BC0100-1

TB0100K / TB0100CPK / TB0130K / TB0130CPK

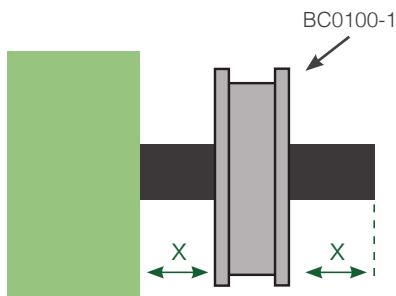
Old OE design

New OE design

When replacing the old tensioner for the new version please use the instructions below:

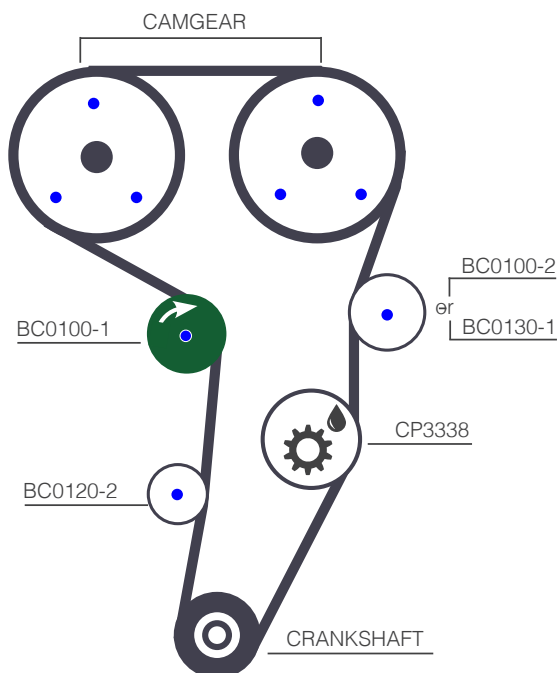
1. Fit the BC0100-1 loosely onto the new stud, about halfway along the stud.

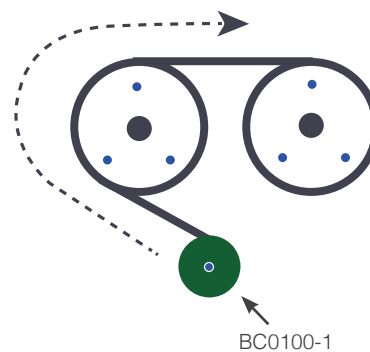
3. Slowly work the belt onto the second camgear and then the water pump, whilst allowing the tensioner to float freely on the stud.

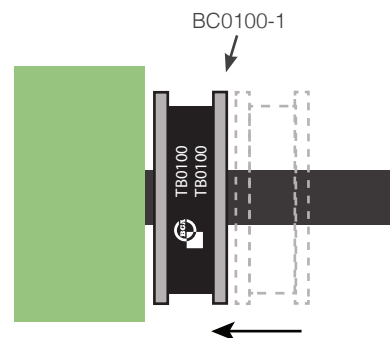
2. Fit the new belt (TB0100) in a clockwise direction starting at the crankshaft pulley. Place the belt in the tensioner and around the left hand cam-gear pulley.
